Remington Arms Company, Inc.
Ilion, N.Y., U.S.A.

As an admirer of your Mod. 37 Rifle, I was delighted to obtain the model 40X from Messrs. Zeniuk & Co., Haifa, Israel, as soon as it arrived in this country - namely on February 13th this year.

FIG 3

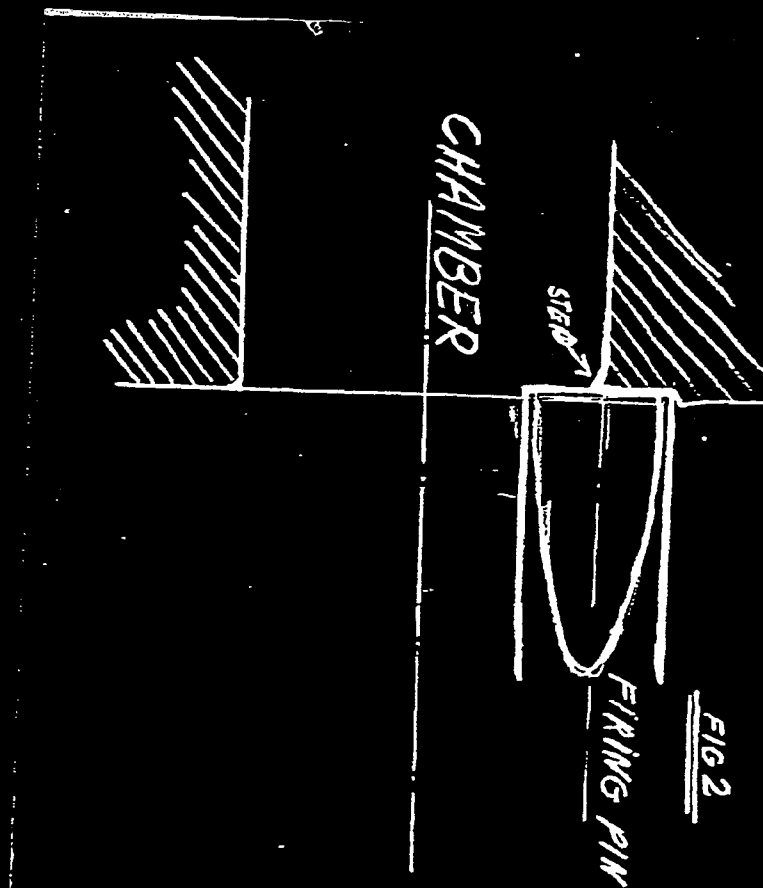
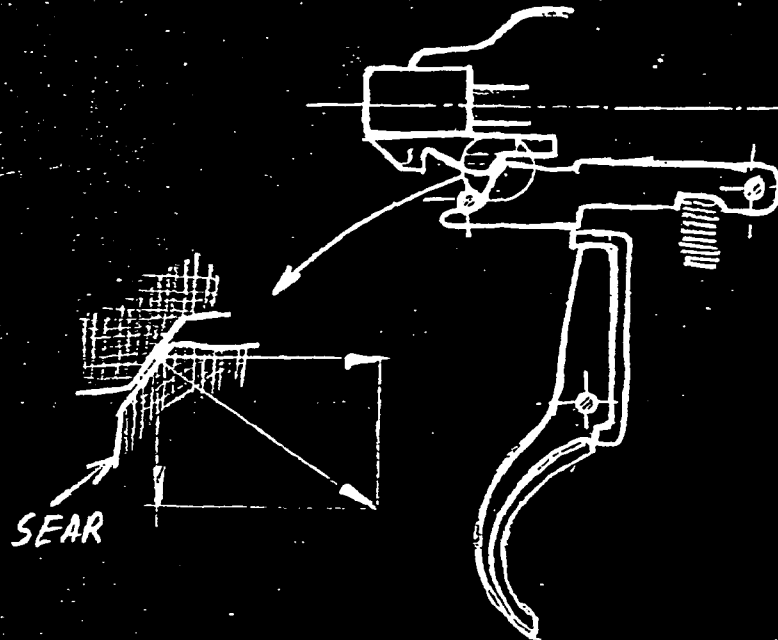
The disappointment came from the trigger action and here is the story: On the very day of the purchase, after several "dry shots" at home, the bolt got stuck and would not lock unless forced brutally.. The safety lever would not function. The stock removed, the surface of the firing pin head was found to be riding over the sear surface. On further dismantling of the trigger mechanism, the cause was revealed: the trigger with the connector have sunk. I cannot state the cause; it was due, presumably to either the poor quality of the trigger alloy or to liberal tolerances (pins placings and such). Fig. No. 3 will illustrate the above.

FIG 4

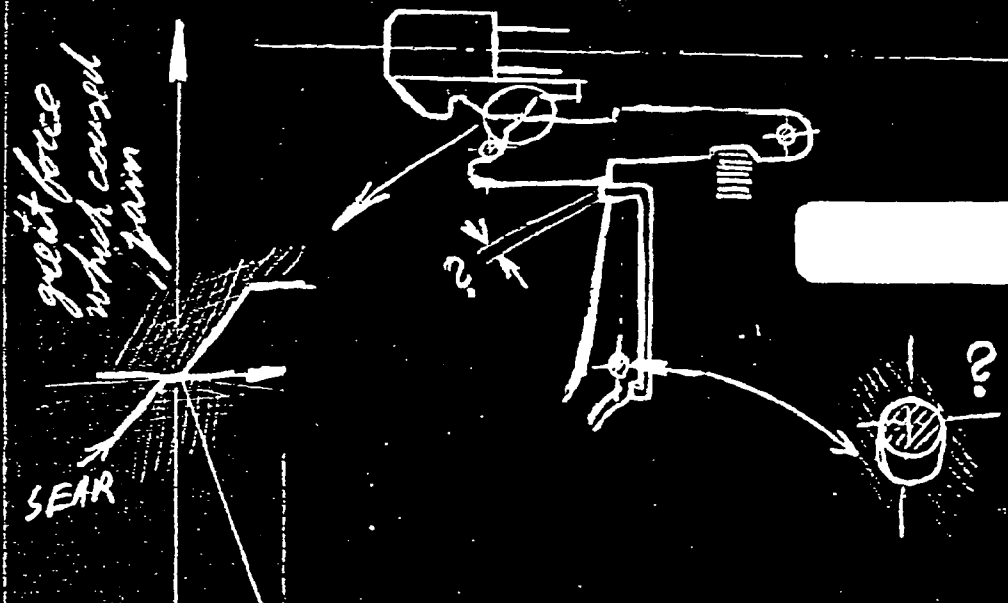
I had to order a new connector with a thicker head and, seeing no reason why it should not be connected to the trigger, I fixed the two bodies together by means of a 1/8" screw. The latter arrangement enabled me to replace the original heavy trigger spring by a lighter one aiming for a lighter pull. Please inform me whether you approve of the above. The click adjustment of the trigger is most convenient but unscrewing the trigger adjusting screw too much, causes the "trigger adjusting ball" to be pushed outside by the spring and removing of the stock becomes necessary. I suggest that the above be eliminated by addition of a thin pin-extension to the "trigger adjusting screw" (see fig. No.4). It proved successful on my rifle.
